**BLUE BARN ROAD SUBDIVISION**  
**MAJOR PLAN 2020-107**  
**ATTACHMENTS**

**TO: PLANNING COMMISSION**  
**FROM: GREGG R. ADAMS, PLANNER**  
**SUBJECT: BLUE BARN ROAD SUBDIVISION**  
**MAJOR PLAN 2020-107**  
**REQUEST FOR SKETCH PLAN REVIEW**

RE: Blue Barn Subdivision  
South Whitehall Township, Lehigh County, Pennsylvania  
Sketch Plan Review  
SWT File Application No. 2020-107

Re: Blue Barn Rd. Major Subdivision  
Land Development #2020-107  
Review of Sketch Plan  
SSM File 103400.0051

DATE: 3/20/23  
SCALE: 1"=100'  
PROJECT NO: 4683(2023)  
SHEET NO: 01 OF 01

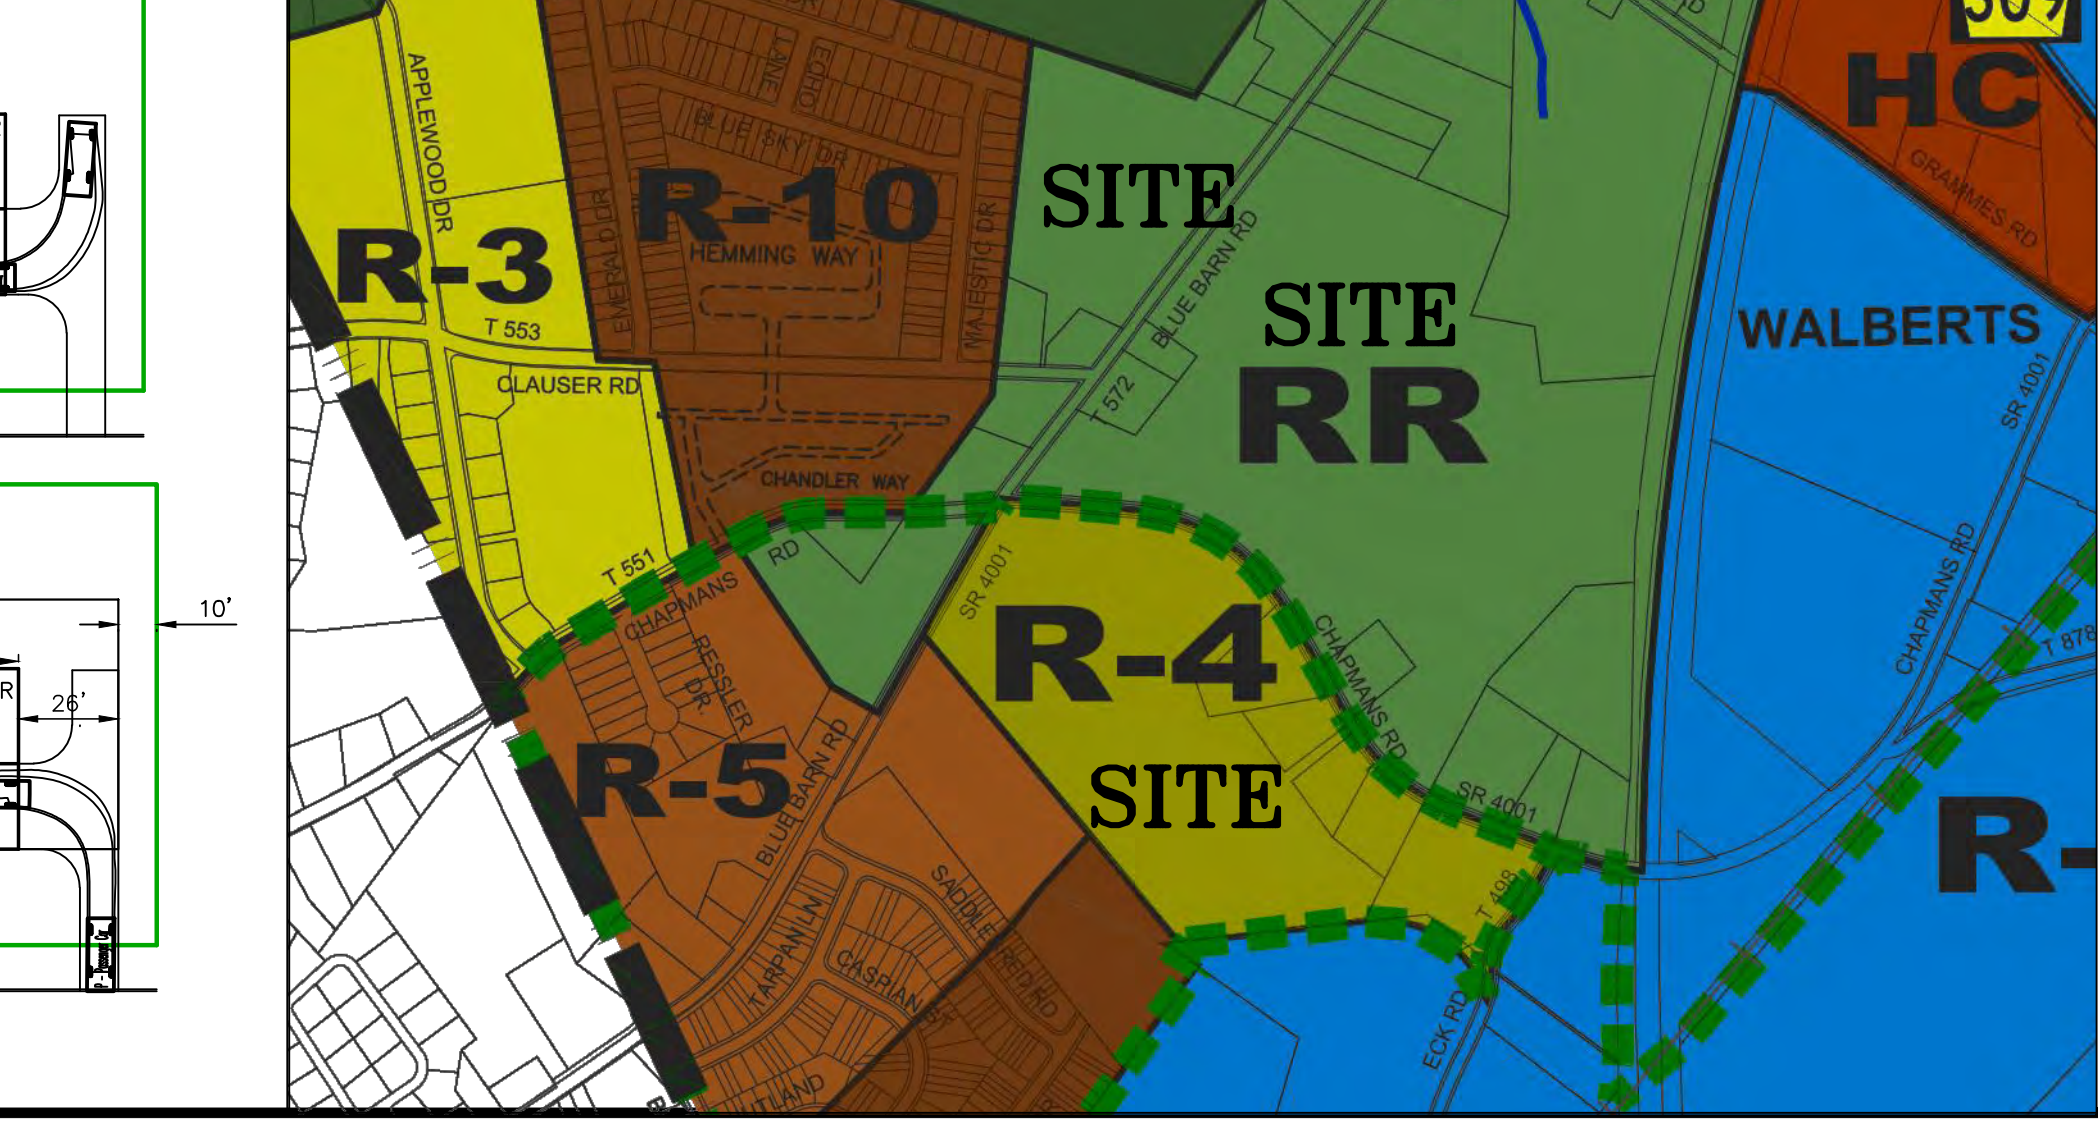
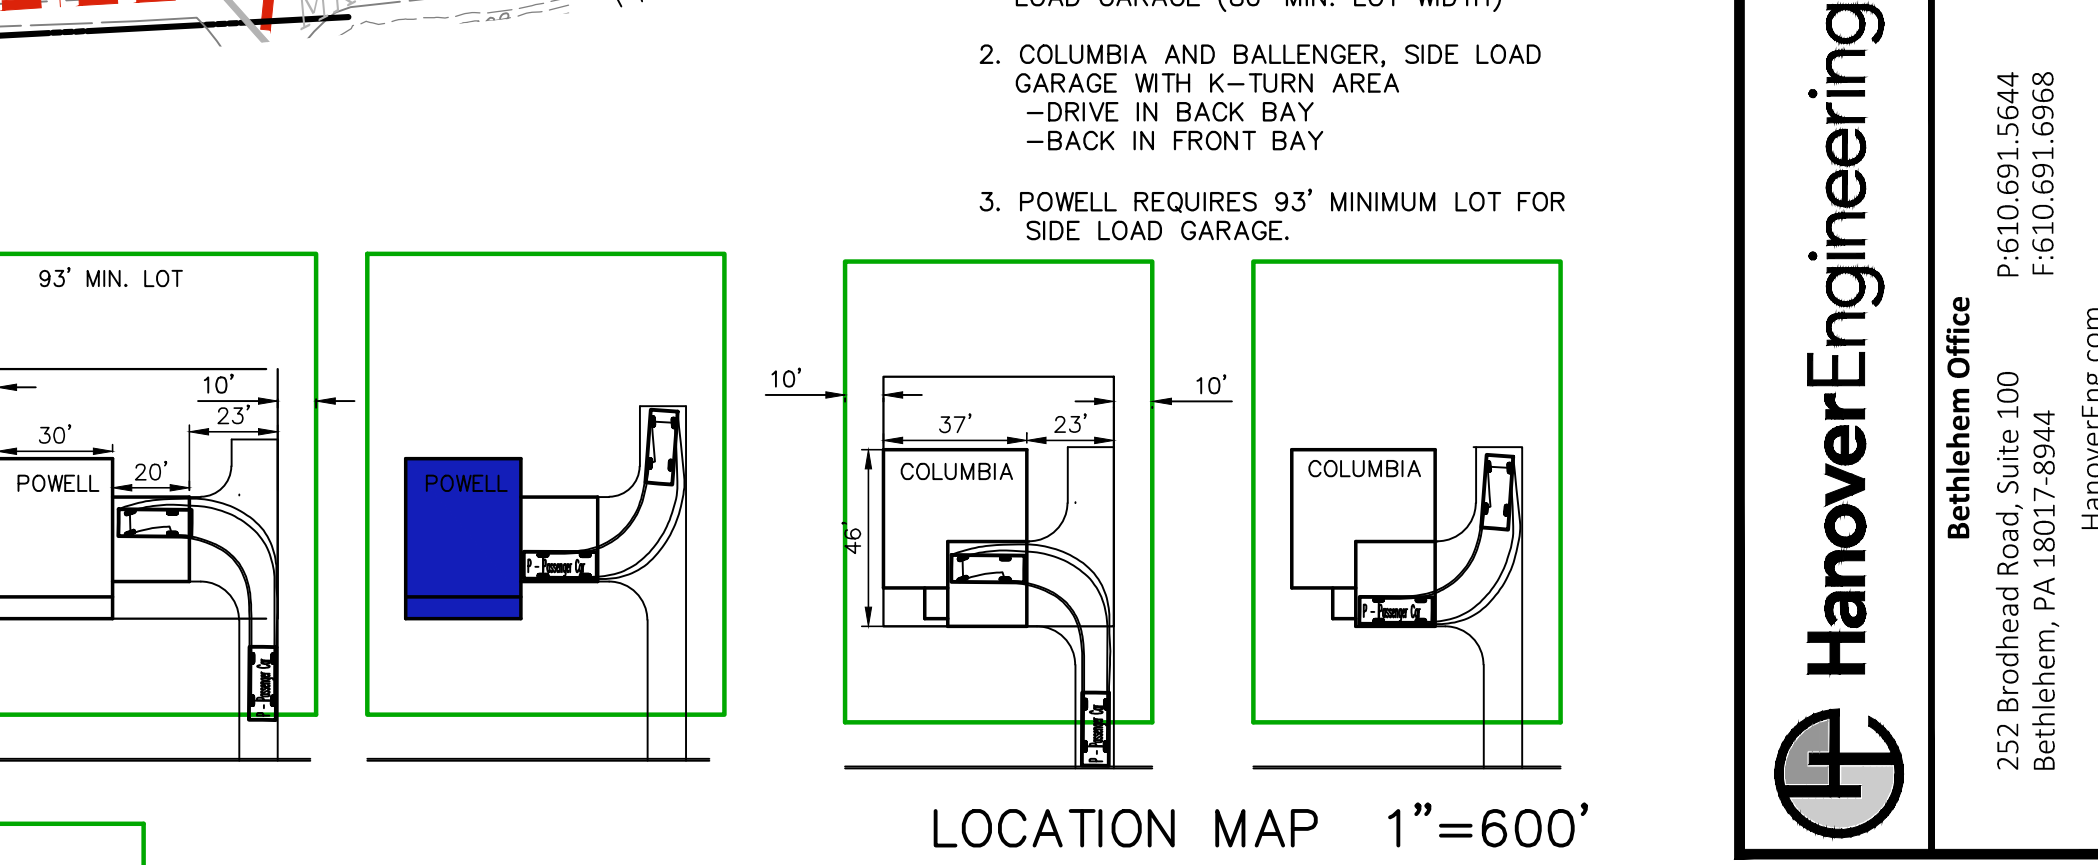
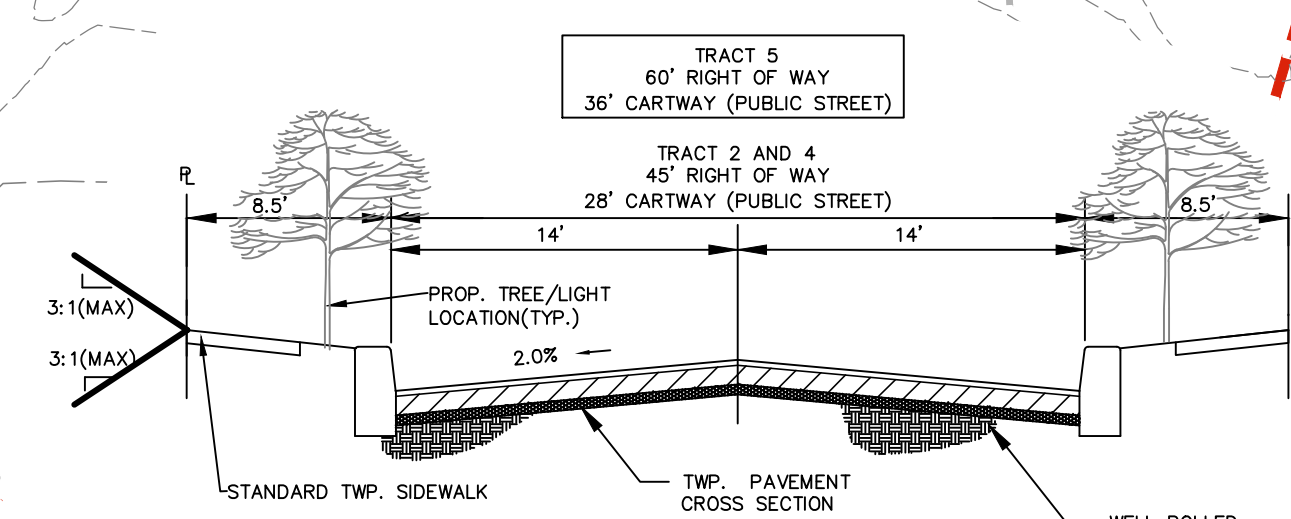
1. **Zoning § 350-24(c)(3)** – The frontage width of Lots 15 and 16 shall be verified. It is noted that the frontage widths may be honored at the setback line, provided the length of the right-of-way line equals at least 60% of the required frontage, in accordance with § 350-42(l)(1).

2. **Zoning § 350-24(c)(3), SALDO § 312-36.B.(1)(a)** – The front and rear yard setbacks shown on Lots RR1, RR2 and RR3 should be 50 feet. In addition, no side yards are shown for Lots 1-8 and Lot RR3 on Tract 4. Furthermore, no setbacks are shown on Tract 3.

3. **Zoning § 350-24(c)(7)** – The Site Data table for the R-5 zoning district lists incorrect side and rear yard setbacks for Two-Flat uses. It is noted that the plan does not propose two-flat uses, but this table shall be revised for accuracy.

6. **SALDO § 312-10.B.(5)(a)** – The gross areas listed for each tract do not match the acreages on the provided deeds. Please clarify.
7. **SALDO § 312-10.B.(5)(d)** – The type of water supply system shall be provided on the Sketch Plan.

17. **SALDO § 312-35.A.(6)(c)** – Intersections shall intersect at 90°. It appears that the Road 5-1/Road 2 intersection with Chapmans Road is less than 90°. This should be revised.

18. **SALDO § 312-35.A.(6)(e)[1]** – Centerlines of intersecting streets shall be offset a minimum of eight hundred feet (800') from the nearest intersecting street along arterial streets. It is noted that Blue Barn Road and Chapmans Road are both classified as Minor Arterial roadways on the Official Map of South Whitehall Township. The following proposed intersections have less than the required offset from adjacent streets and shall be revised accordingly:

- A. Road 4-1 at intersection with Chapmans Road. This intersection appears to be offset slightly from Chandler Way on the opposite side of the street. The roadway shall be designed so the centerline is aligned with the centerline of Chandler Way.

- B. Road 2 at the intersection with Blue Barn Road. This intersection is less than 800' from the centerline of Clauser Road. These intersections are approximately 760' apart as proposed.

- C. Road 2/Road 5-1 at the intersection with Chapmans Road. This intersection is located less than 800' from the centerline with Blue Barn Road. These intersections are approximately 430' apart as proposed.

20. \* **SALDO § 312-35.B.(2)(b)[1]** – Dead-end streets, other than stub and cul-de-sac street, shall be prohibited. Road 5-1 is proposed to extend beyond the intersection with Road 5-4 and dead-ends. In addition, a stub street is proposed at the terminus of Road 5-4 and ends at the edge of the adjacent property to the south. The Planning Commission should review the proposed dead-end street and stub street and may wish to provide comment.

31. **SALDO § 312-36.B.(3)** – The lot lines of corner lots shall be rounded to a minimum radius of 20 feet. The lot lines on Lots 1 and RR1 shall be rounded at the intersection with Chapmans Road.

33. **SALDO § 312-36.B.(6)(b)** – Setbacks on corner lots shall apply from both ultimate street rights-of-way. The setbacks on Lots 1 and RR1 do not appear to be correctly shown.

36. **SALDO § 312-36.D.(4)(b)[1]** – The required amount of open space for Tract 2 is incorrectly tabulated under the Open Space Tabulation.
37. **SALDO § 312-36.D.(4)(b)[3]** – The area shown as Prime Open Space on Tract 5 has slopes greater than 6% and would not qualify as prime open space as a whole or part.

58. \* **Section § 296-38** – The Sketch Plan shows a total of six (6) potential stormwater management areas. Five (5) areas are located on non-building lots that also include adjacent open space areas to be dedicated to the Township. The remaining area, located on Tract 2, straddles Lots 3 and 4. The Township Staff and the Planning Commission should review and may wish to comment on their preference for stormwater facilities to be dedicated to the Township. It is recommended that stormwater facilities be contained on a single lot.

64. The driveway located to the south of the Road 5-2 intersection with Blue Barn Road should be shown on the plans.
65. It is recommended that Lot 5 on Tract 1 have restricted access to Clauser Street.

66. The applicant should clarify the intended use on Tract 3.
67. The applicant should clarify the intent of the subdivided parcel of land on Tract 5 that is located between the two existing dwelling that abut this parcel.

68. The proposed Chapmans Road right-of-way shall be aligned with the existing rights-of-way to the immediate west of Tract 3.
